E5070A-03

S E R V I C E N O T E

E5070A ENA Series Network Analyzer, 300 kHz to 3 GHz

Handler I/O Port Malfunction Due to TTL-Low Level Threshold Voltage Anomaly

Figure 1. Threshold voltage anomaly

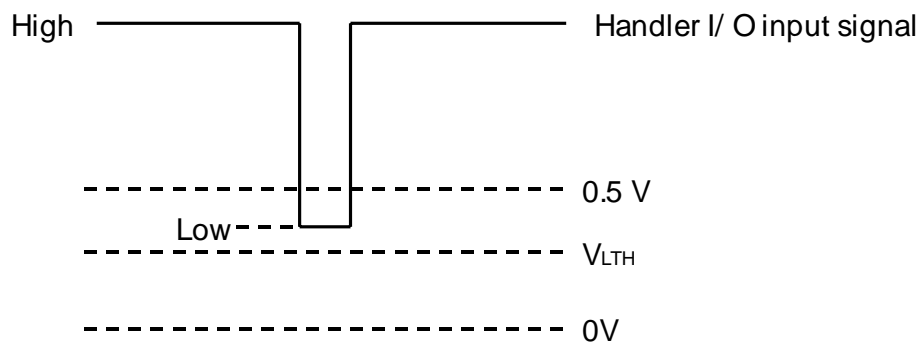
The 24-bit handler I/O of the E5070A units with the specified serial numbers may not function normally. Due to the possible threshold-voltage anomaly of TTL input circuit at either of the I/O pins 2, 18 and 22 through 29, the handler I/O port may ignore the “Low” state of control input signals. When the threshold voltage for TTL-Low level is too low (lower than 0.5 V), it is possible that control input signal does not cross the threshold voltage (V_{LTH}) though the “Low” level of the signal is within the recommended voltage range (0 V to 0.5 V). As a result, a handler interface error occurs. See Figure 1.

When the threshold voltage of the handler I/O (either of the I/O pins) is too low, replace the A23 Handler I/O board with new one (P/N E5070-61006).
